ECE/TRANS/WP.29/GRE/2007/65  
4 September 2007

**COLLECTIVE AMENDMENTS**  
Regulations Nos. 6, 7 and 48

Proposal for draft corrigendum 1 to Supplement 15 to  
the 01 series of amendments Regulation No. 6  
(Direction indicators)

Transmitted by the expert from France

Front direction indicator  
of categories 1, 1a or 1b

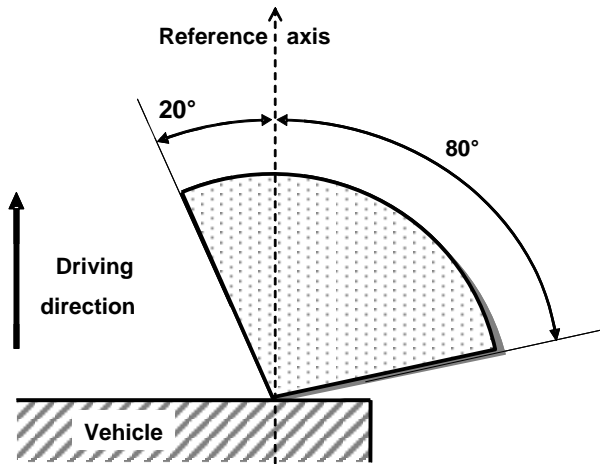
(a) Direction indicators for the front of the vehicle

Category 1: for use at a distance not less than 40 mm from the headlamp;

Category 1a: for use at a distance greater than 20 mm but less than 40 mm from the headlamp;

Category 1b: for use at a distance less than 20 mm from the headlamp.

### 2. Front direction indicators, inboard horizontal visibility.

The interior visibility angle reduction of the front direction indicator from 45° to 20° has a minimum impact on the distance of visibility of the vehicle when observed along its longitudinal median plan. In the case of a vehicle with 1400 mm between the reference axis of the direction indicator lamps, this angular reduction, as seen by an observer standing on the median longitudinal plan of the vehicle, leads to a minimal change of just 1.22 m:

With the current visibility angle, the lamp is visible at  $D_1 = 1400 \times 0.5 \cotg 45^\circ$ .

With the proposed visibility angle, the lamp is visible at  $D_2 = 1400 \times 0.5 \cotg 20^\circ$ .

The "danger" distance is increased by a modest  $D_2 - D_1 = 1400 \times 0.5 (\cotg 20^\circ - \cotg 45^\circ) = 1220 \text{ mm}$ .

This angular modification allows more pedestrian-friendly front ends. It improves the aerodynamics, thus reducing the fuel consumption of the vehicle.

Rear direction indicator  
of categories 2a or 2b

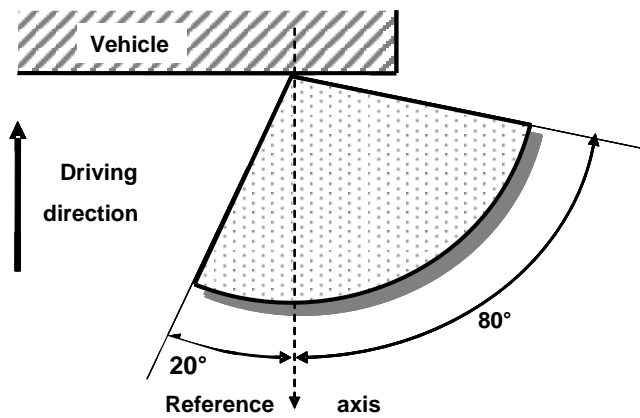
Category 2a: rear direction indicator lamps with steady luminous intensity.

Category 2b: rear direction indicator lamps with variable luminous intensity.

3. Rear direction indicators, inboard horizontal visibility.

This proposal is solely based on styling considerations. Pedestrian protection and aerodynamics do not apply to parts that are installed at the rear end of the vehicle.

### 1. Front or rear direction indicators, vertical visibility.

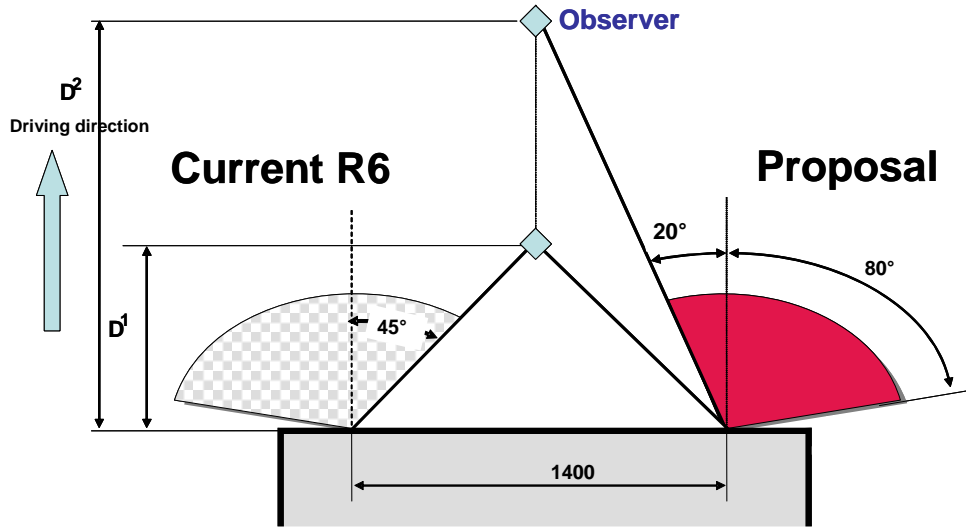
The current limit of 750 mm in height is somewhat arbitrary. The proposed formulae to Annex 1 (a) create a smooth transition between these two angles and remove the threshold effect.

**Case 1:**

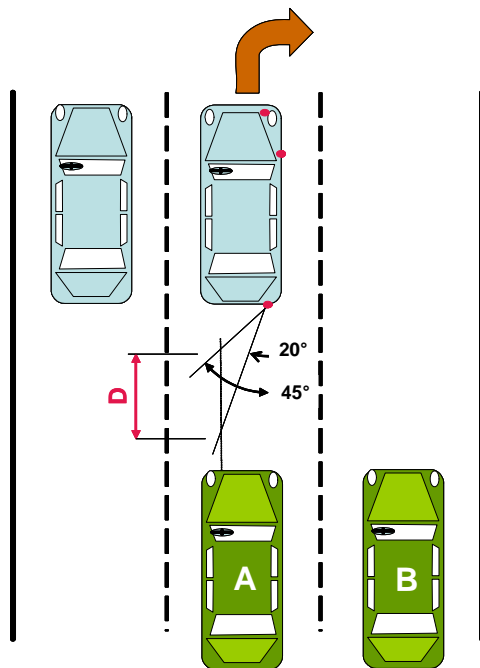
The inboard visibility angles reduction does not jeopardize safety, as shown by the following three sketches:

The following vehicle A experiences a small reduction of its visibility distance:

$$D = e (\cotg 20^\circ - \cotg 45^\circ)$$

**Case 2:**

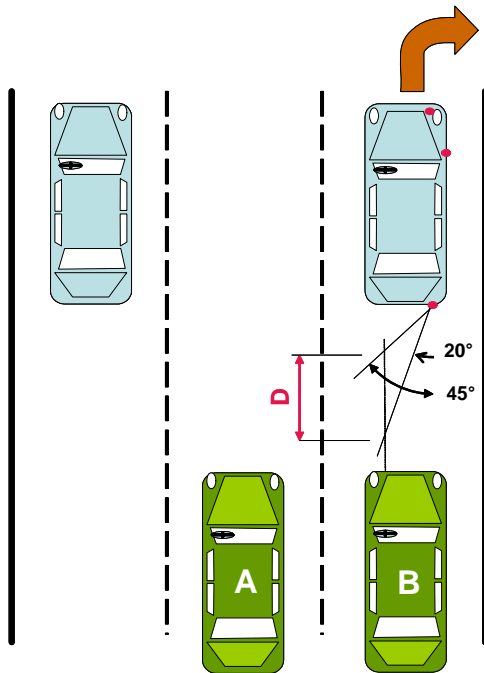
The safety of vehicle B is unchanged because the outer visibility angles are not concerned by the proposal.

The following vehicle B experiences a small reduction of its visibility distance:

**Case 3:**

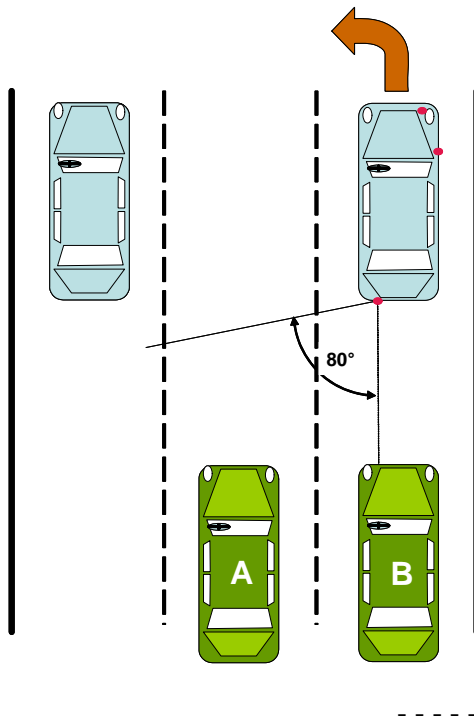
$$D = e (\cotg 20^\circ - \cotg 45^\circ)$$

No safety issue for both vehicles:

Vehicle B is not concerned, and, the 80° outer angle being unchanged, the visibility of vehicle A is not altered by the proposal.
